## service bulletin

No. 88-3

Replacement starter motor P/N 50-12872 for Mer-Cruiser models.

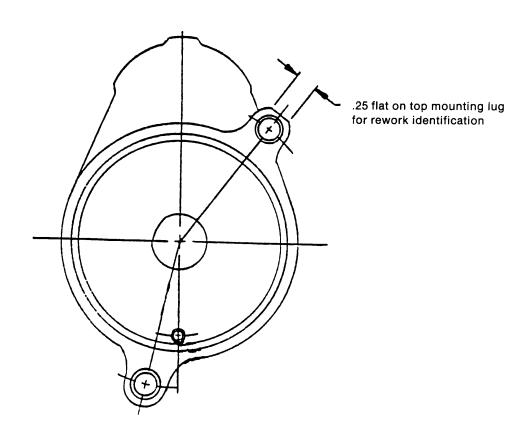
Loose starters received after November 1, 1987, have been reworked and can be identified by visual inspection of the pin pressed into the front of the starter nose piece. Two repair methods were used to upgrade the flame proof condition of the starters. Starters having a heavy-duty coiled spring pin or two spring pins, one inside the other, installed in the front of the starter nose piece can be used as is.

Two different methods were used to identify reworked starters by Ford activities. These are shown below and if your starter is on an engine, it should be checked for either identification.

1. A 1/4" wide flat has been filed on the top mounting lug of the starter nose piece as shown below:

2. A 1/4" high "R" stamped adjacent to the date code as shown in the sample below:

- 1. Remove the starter motor from the engine in accordance with established removal procedures.
- 2. Once the starter motor has been removed or if it is loose, locate the spring pin in the nose piece as shown on the sketch below.
- 3. Without disassembling the starter motor, remove the spring pin with cutting pliers; vise grip pliers or regular pliers.
- 4. Lightly oil the replacement part (a heavy-duty coiled spring pin, Ford part number 67809), align it with the hole in the nose piece and gently tap it in place with a small hammer. Drive it in until the end of the pin is 1/4-inch to 5/16-inch from the starter motor mounting surface (see sketch below).
- 5. Reinstall starter motor in accordance with established procedures.
